**MetroLink**

## **Additional Errata Relating to Chapter 20**

Document Title: Additional Errata Relating to Chapter 20

Chapter 20 addresses Geology and Soils within the EIAR.

This drawing is not to be used in whole in or part other than for the intended purpose and project as defined on this drawing. Refer to the contract for full terms and conditions.

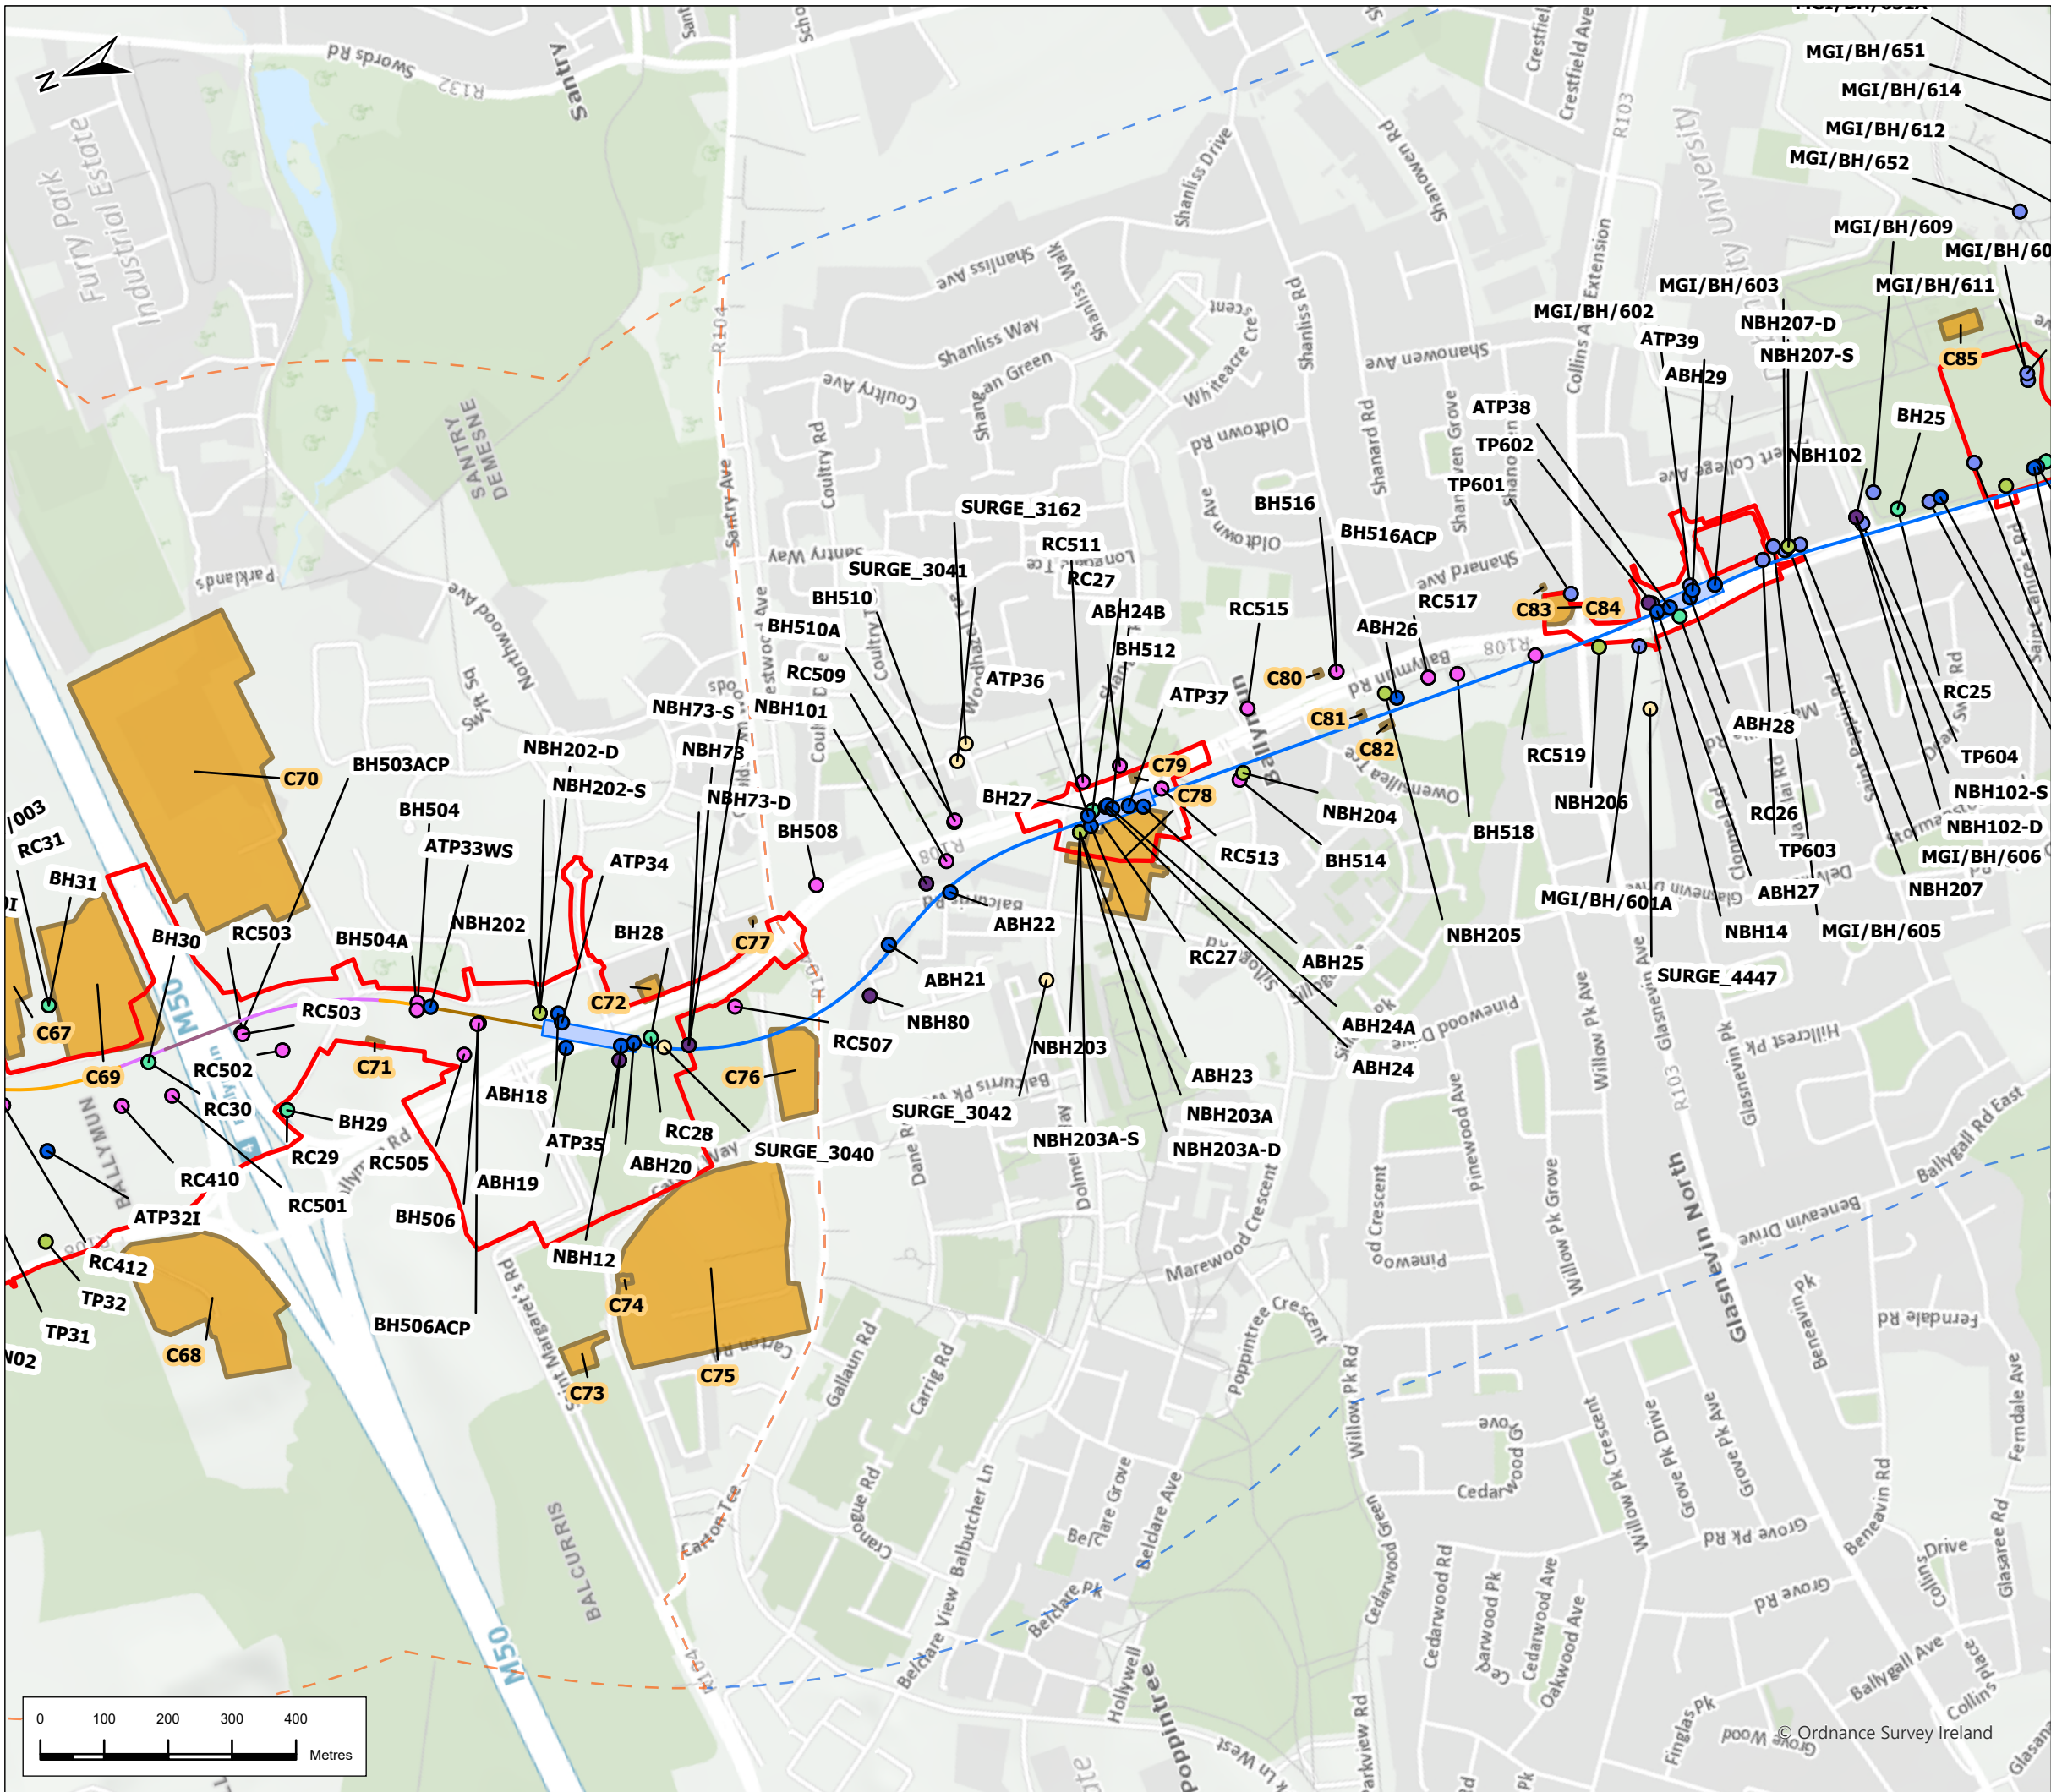
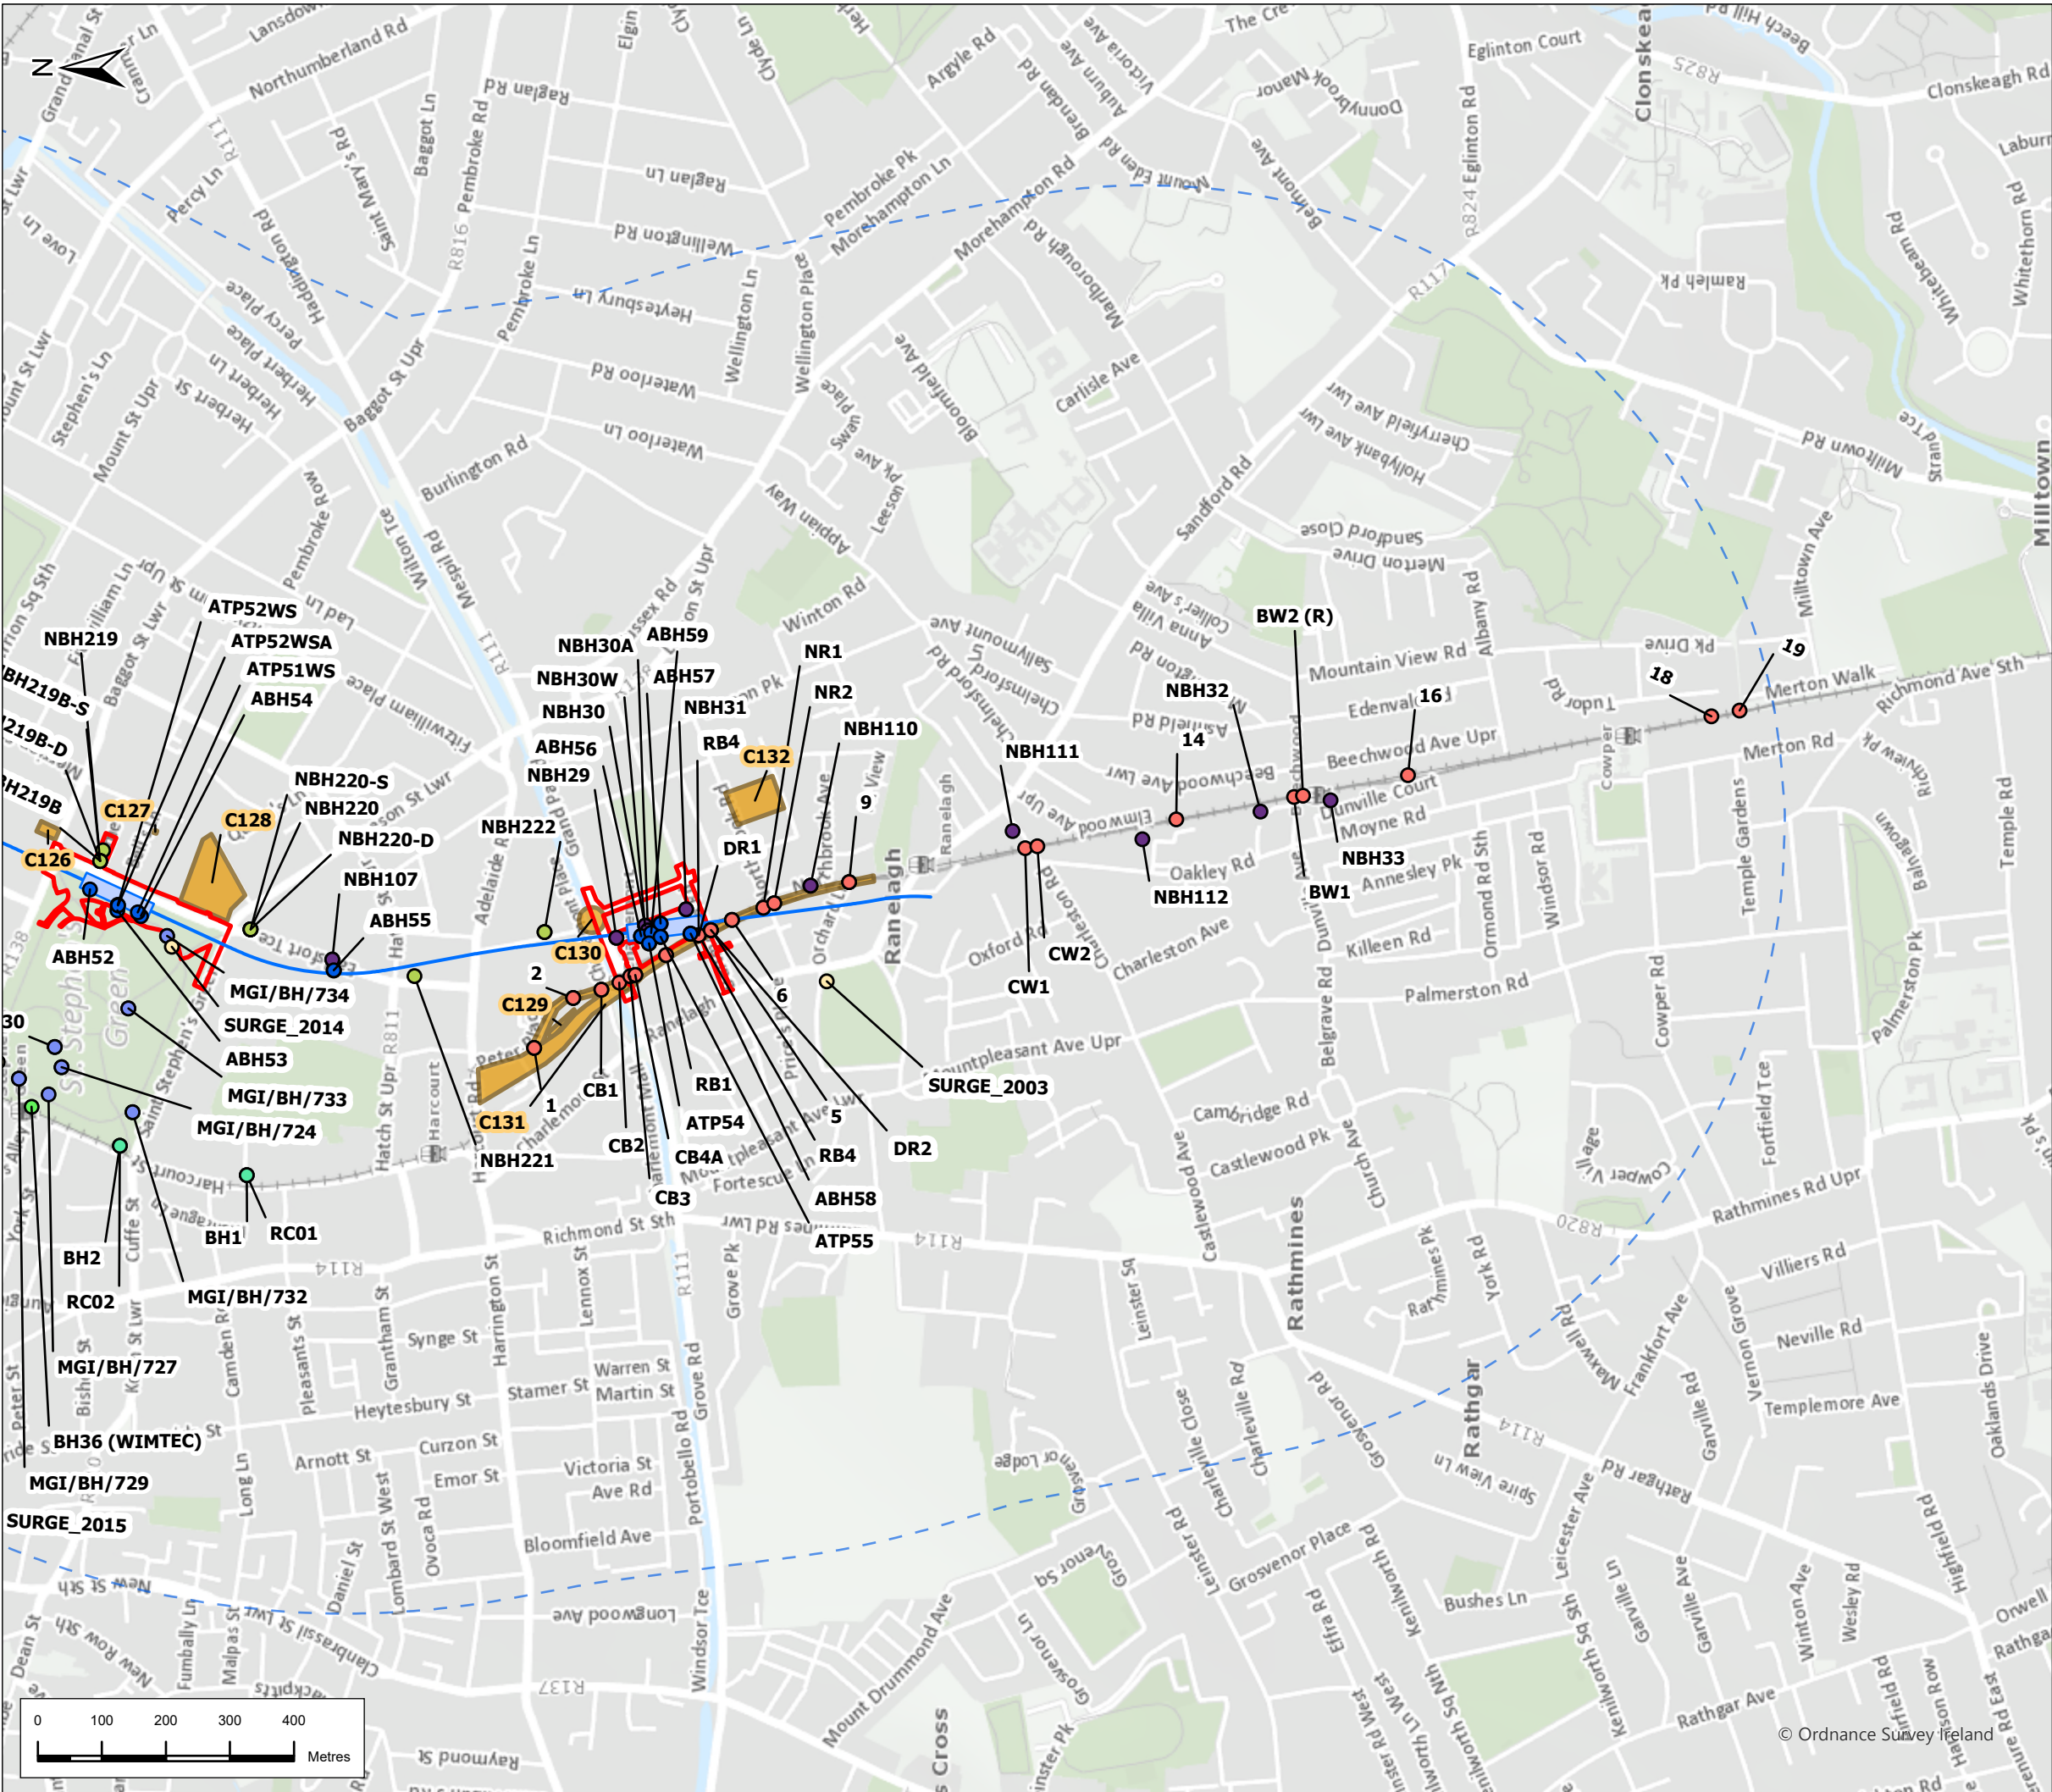
It has become clear during the course of the oral hearing that, in error, borehole locations which appeared in an early drawing of proposed bore hole locations, and which did not form part of the Geotechnical Investigation (GI) scope, were included in error in the chapter presentation as follows:

- Figure 20.6 (Revised version attached)
- Appendix A20.1 (Summary of Supporting Ground Investigation Scope)
- Appendix A20.2 (Summary of Relevant Exploratory Hole Locations and Monitoring data)
- Appendix 20.8 (Appendix A Tables A1 to A4) and Figure 20.6.

Chapter 20 includes summaries of the ground investigation (GI) data used in development of the assessment as detailed above as well as a figure detailing the GI locations. An error has been identified whereby proposed borehole locations which were not actually drilled were included in the summary tables detailed above and Figure 20.6. These borehole locations were not drilled as they were not required. The proposed Phase 1 borehole references included in error are listed in Table 1.

The inclusion of these proposed GI location references was mistaken, and it should be noted that boreholes at these proposed GI locations were not drilled. Consequently, there is no data associated with these proposed locations.

The geological cross sections included within the EIAR were developed on the basis of the GI locations actually completed and, as such, are not affected. The resulting interpretation of geology included in Chapter 20 (Soils and Geology) and Chapter 19 (Hydrogeology) is unchanged.
